## Product change notification (PCN)

<b>Title / short description</b>	Nominal voltage for metric circular signal connectors changed to 48 V AC
<b>Affected article category</b>	Connectors
<b>Change category</b>	Function
<b>Change number</b>	CAB200045-02

CAB200045 – Change of insulation body marking (16+2+PE, series CA)

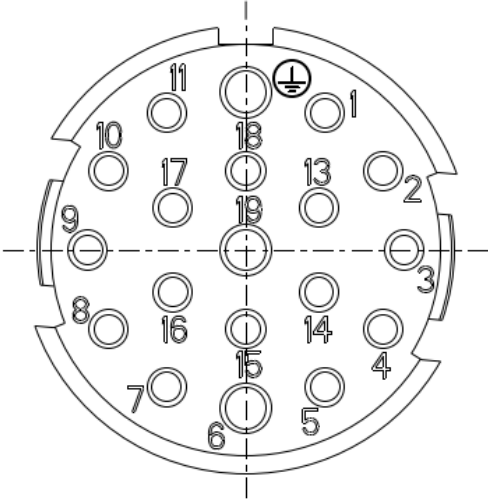
Current design:

new design:
